PI 1877
For technical personnel only!
1/1

PRODUCT INFORMATION

AUXILIARY WATER PUMP FOR AUDI A4/A5/A6/A7/A8/Q5

NOW ALSO AVAILABLE IN AFTERMARKET

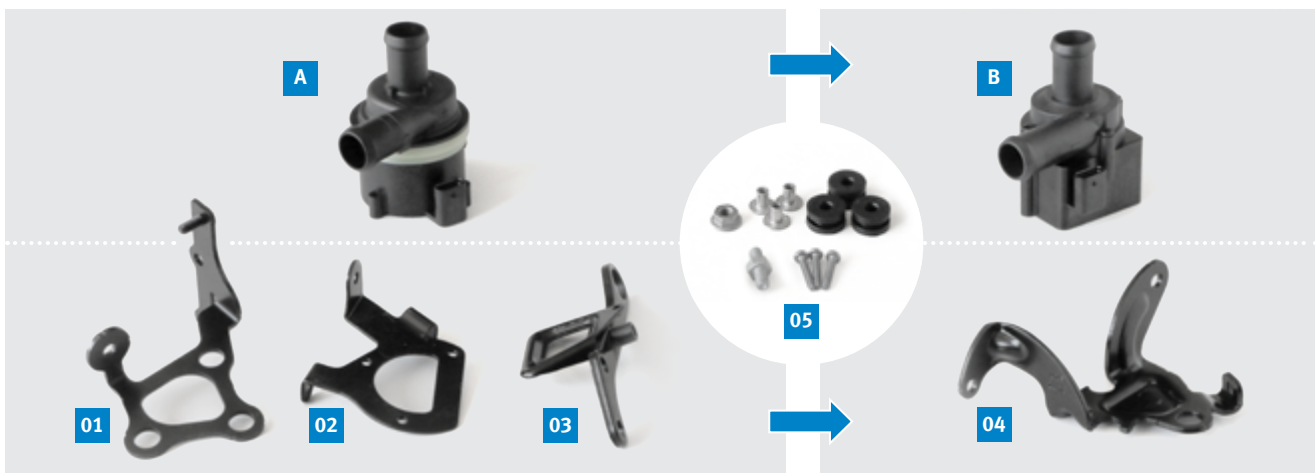
At the start of series production, the pump (A) with the ref no. 059 121 012 B was fitted. This pump was then replaced by a pump from Pierburg (ref. no. 06D 121 601) and a modified holder. The Pierburg pump prevents the problems that arose with the originally fitted series pump.

The original series pump (A) was supplied with three different holders (01), (02), (03) depending on the vehicle model. If the original series pump (A) is still installed in the vehicle, the holder (04) is required (included in the scope of supply). The fixtures (05) can be reused.

The pump **7.10102.05.0 (B)** from Motorservice can be used to replace these pumps.
